P.O.A.D.P. (AMENDED)
LONE STAR BUSINESS PARK
SOUTHEAST CORNER OF IH 10 AND UTSA BLVD.
CITY OF SAN ANTONIO, BEXAR COUNTY, TEXAS

Re: Lone Stare Business Park (Amending) POADP # 591-A

Re: Amendment to POADP No. 591 – Lone Star Business Park
UTSA Blvd. and IH-10
San Antonio, Texas

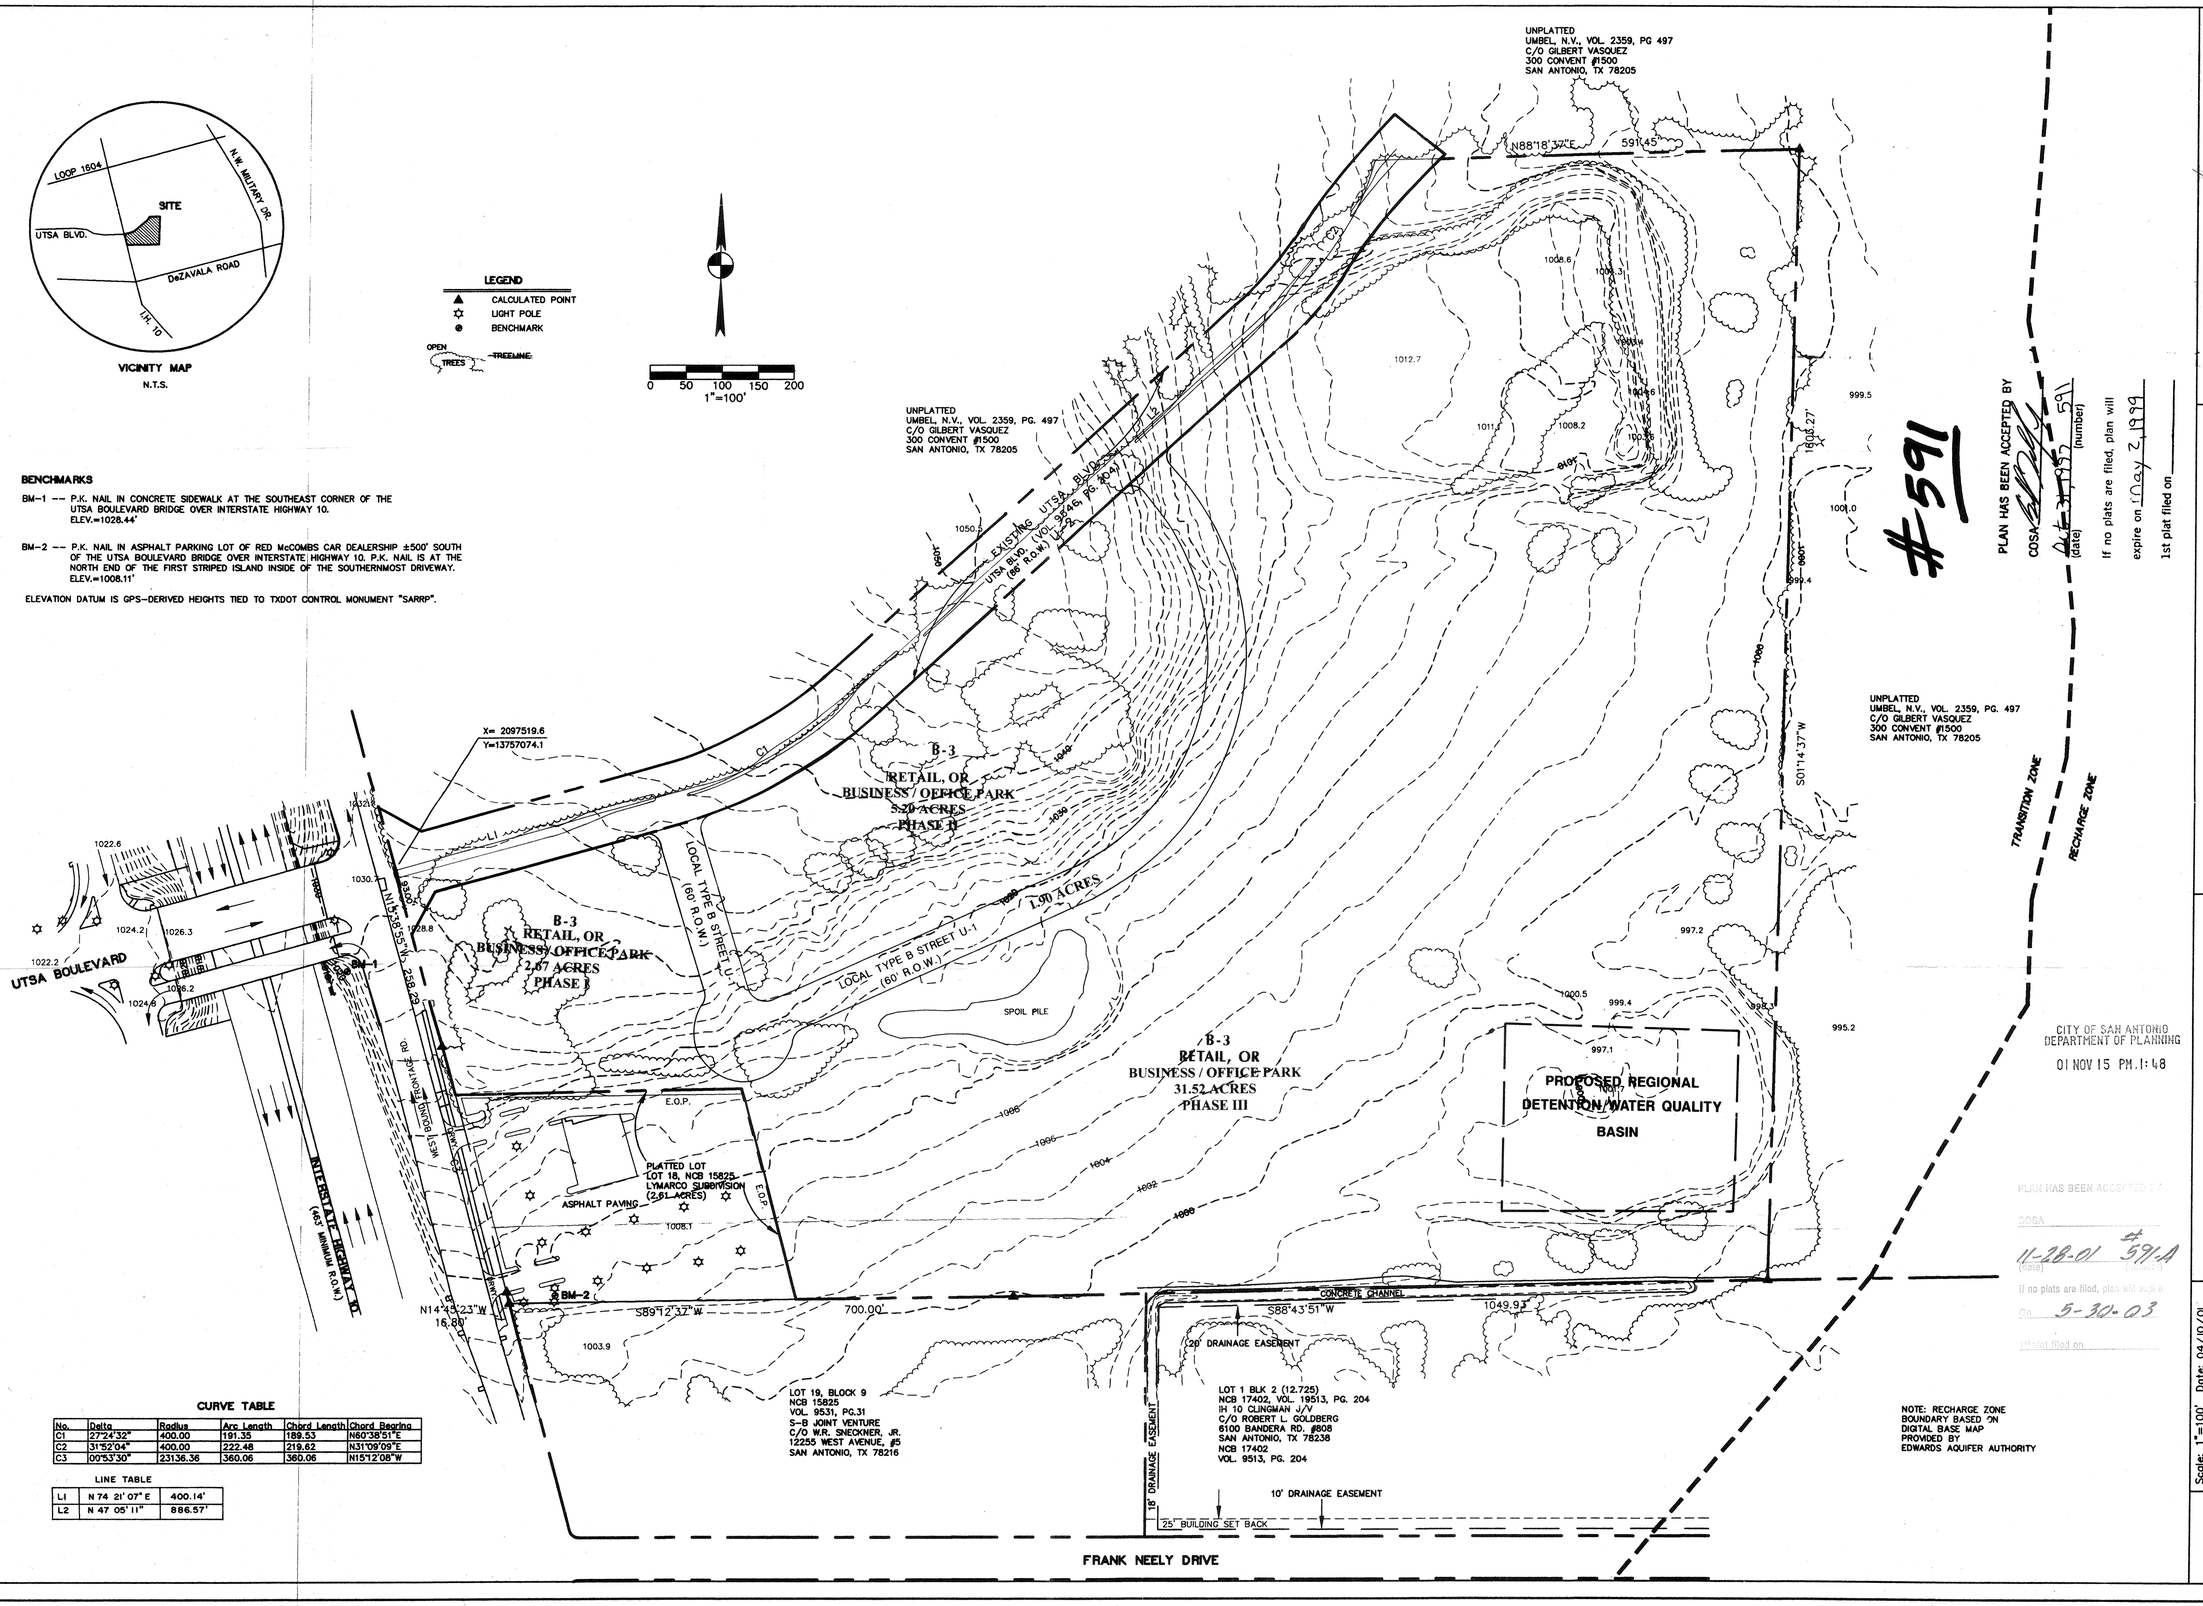
Comments: IH10 IN IS ON THE MTP AND TXDOT SYSTEM REQUIRING A MIN. OF 110' ROW AND TXDOT REVIEW.
UTSA IS ON THE MTP REQUIRING A MIN. OF 86' ROW.

Comments: Identify regional detention pond location.

Comments: ① ADD ZONING "B-3"
② REMOVE "INDUSTRIAL" FROM PROPOSED USE. PROPERTY IS ZONED "B-3" AND DOES NOT ALLOW FOR INDUSTRIAL USES

Pape-Dawson has addressed the outstanding comments from Public Works and Zoning with regard to the referenced POADP amendment. I have met with Kevin Love to resolve the type of street that is proposed for the development and it will remain as a Local Type B street. As requested by Zoning, we have added "B-3" and removed "Industrial" from the POADP.

P.O.A.D.P. (AMENDED)
LONE STAR BUSINESS PARK
SOUTHEAST CORNER OF IH 10 AND UTSA BLVD.
CITY OF SAN ANTONIO, BEXAR COUNTY, TEXAS

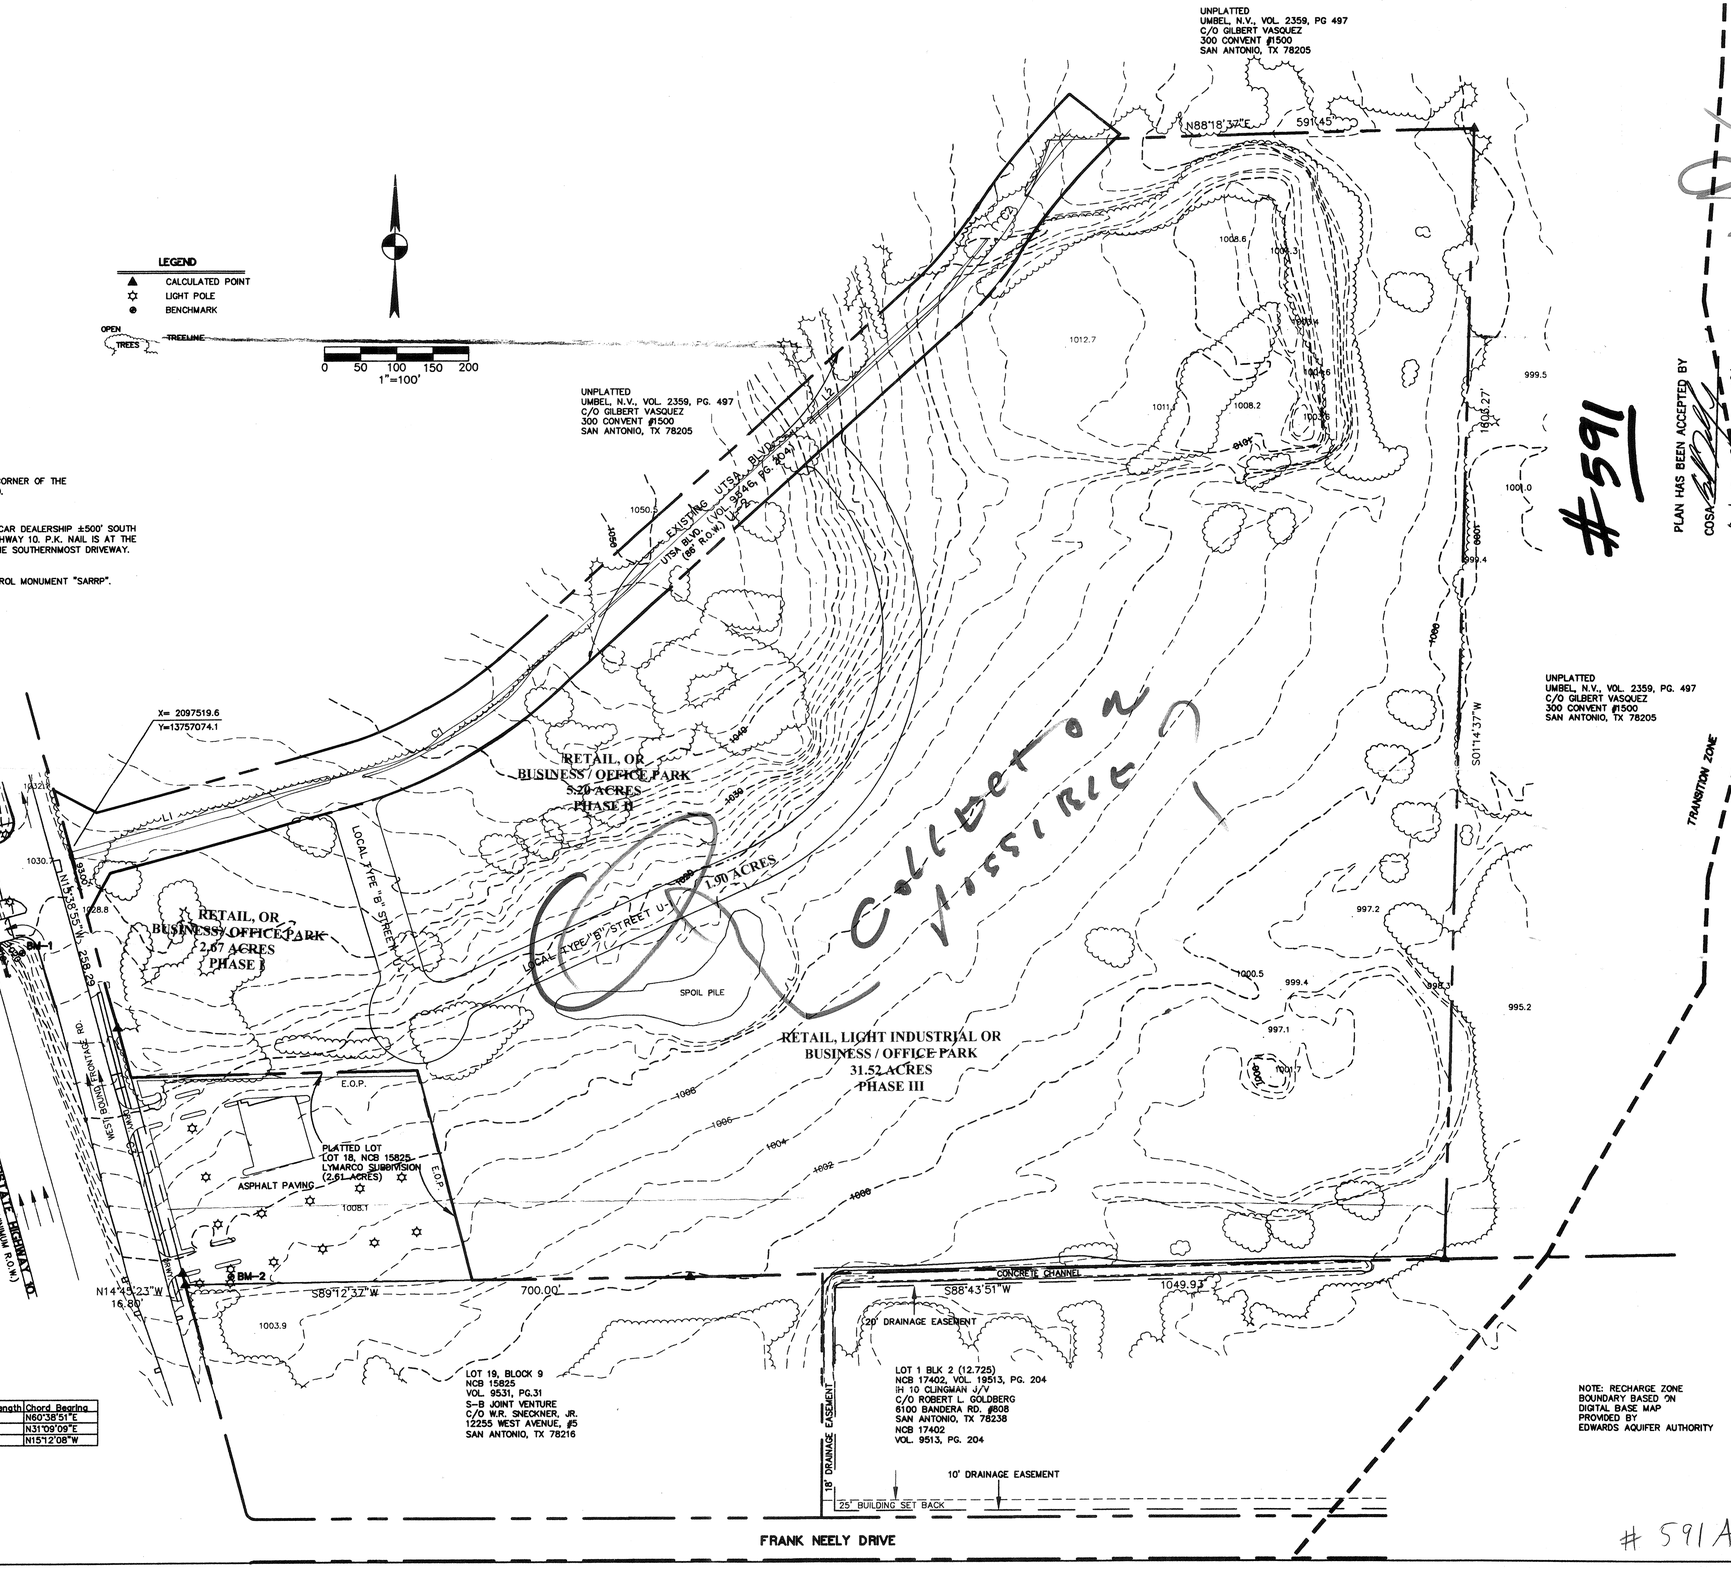
Collect on Missible ?
